Model: EMI-400

Product Bulletin # TDS-198

VFD Safety Relay Wiring

Figure 2: Move indicated wires from relay A61 to A65, plugging into same terminals

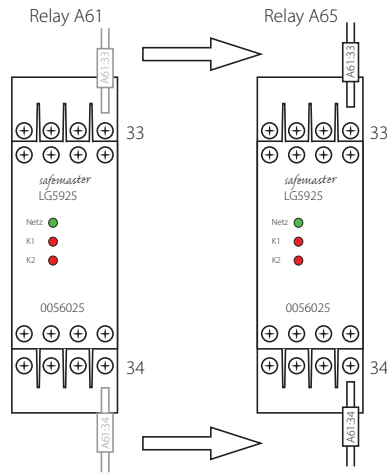
4. Move the wire marked A61:33 on relay A61 to the relay A65 to terminal **A65:33**.
5. Move the wire marked A61:34 on relay A61 to the relay A65 to terminal **A65:34**.

Figure 3: Relay Wiring

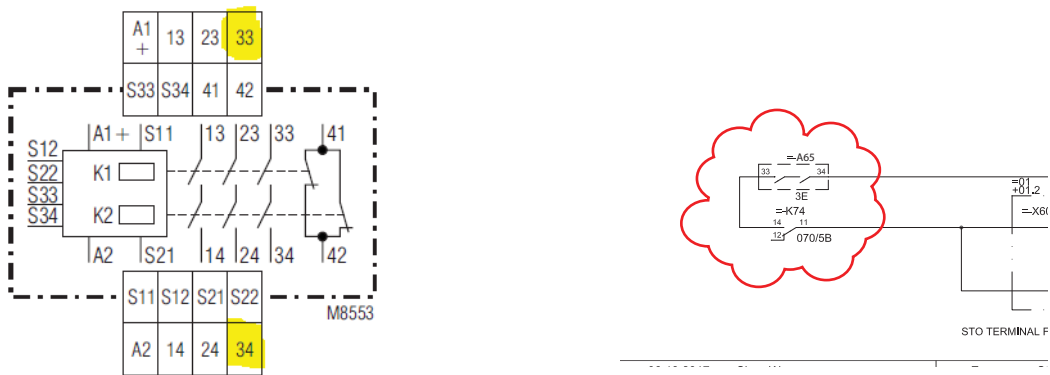
It has come to Canrig's attention that the original equipment manufacturer may have wired some EMI 400 HP VFD houses incorrectly. Only VFDs with ABB ACS880 safety relays were affected. This has been corrected for new builds, but existing VFDs should be inspected and the problem corrected if discovered.
